GGG-F-325B
INT. AMENDMENT 5(NAVY-SH)
May 30, 1980
SUPERSEDING
INTERIM AMENDMENT 4(NAVY-SH)
November 5, 1979

INTERIM AMENDMENT

FEDERAL SPECIFICATION

FILE, HAND (AMERICAN PATTERN) AND RASP, HAND

FIGURE 34. Distortion tester."

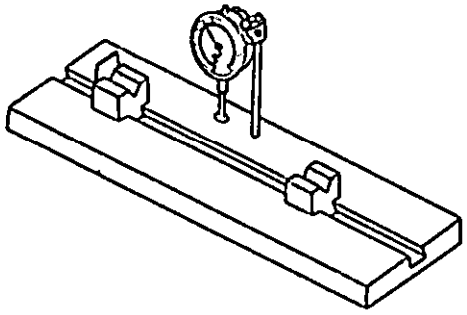
FIGURE 34: Delete and substitute:
